LW26 Wollondilly Shire Council Roads, Bridges and Culverts SSSMP Review

Minutes from Meeting

Date: 22 December 2010

Figure A – Bracket Adjustment Detail (courtesy John Matheson & Associates)

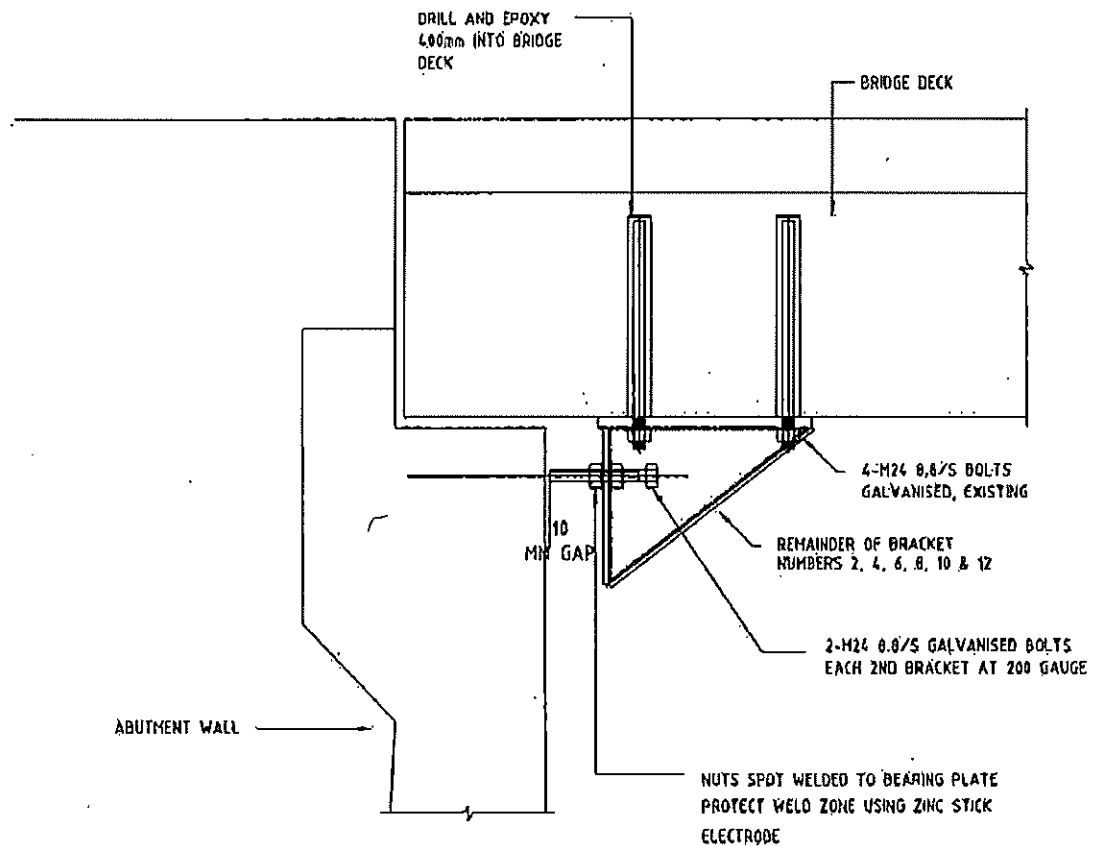
However, at that time, there was concern that the dowels between the top of the abutments and underside of the deck may shear and damage the concrete abutments. Steel brackets were installed to provide additional support to the abutment walls, ensuring that the dowels shear without breaking the concrete that surround them. It was possible, however, that the brackets, after achieving their design purpose of preventing abutment cracking at time of dowel shear, may reach the limit of their bearings and have begun to apply lateral loads onto the abutment walls. It is for this reason that daily inspections were required.

Monitoring of the bridge during the mining Longwall 25 has indicated that the dowels have sheared. Adjustments were therefore made to the brackets so there is currently a small air gap between the abutment walls and the bracket supports so that there is no pressure on the brackets, abutments or bridge deck. The brackets have been left in place to provide some support to the abutments and they can be easily re-adjusted during mining. A sketch showing the adjustment of the brackets is shown below.

It is for the above reasons that a frequency of weekly visual inspections is considered adequate during the mining of Longwall 26. However, as described in the Management Plan, the Structures Response Group may increase the frequency of visual inspections at any time, based on actual movements observed during the mining of Longwall 26. The Structures Response Group may also decide to undertake additional structural inspections at any time during mining, as were undertaken during the mining of Longwall 25.

2.8 The scaffold beneath the deck at both abutments will be re-erected prior to the longwall approaching Castlereagh Street Bridge to provide access for detailed visual inspections and to allow the gap between the abutment walls and the brackets to be measured.
